CLIO II

ACCELERATOR CABLE (RIGHT-HAND DRIVE VEHICLES)
OTS: 0A2M MARK : F1

Preventive operation:

- Replacement of the accelerator cable.

Fig. 1

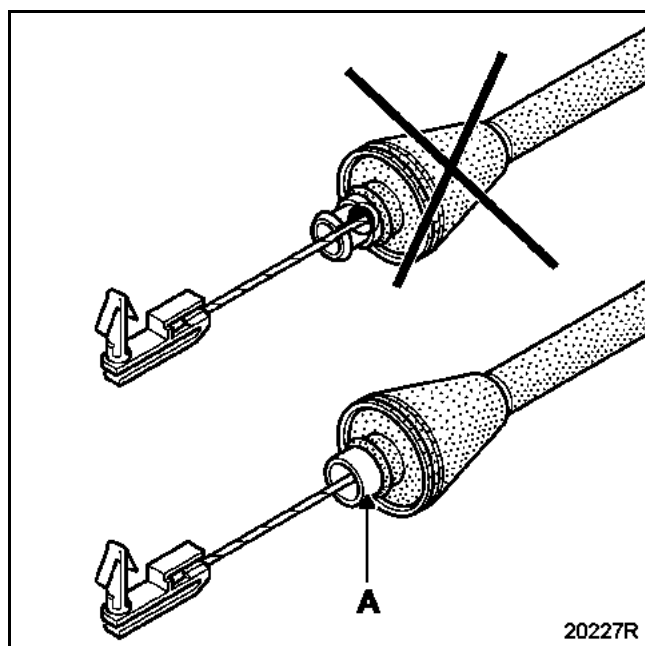
- Replace the accelerator cable with a new accelerator cable (A) (**Fig. 1**).

A - New sleeve end piece
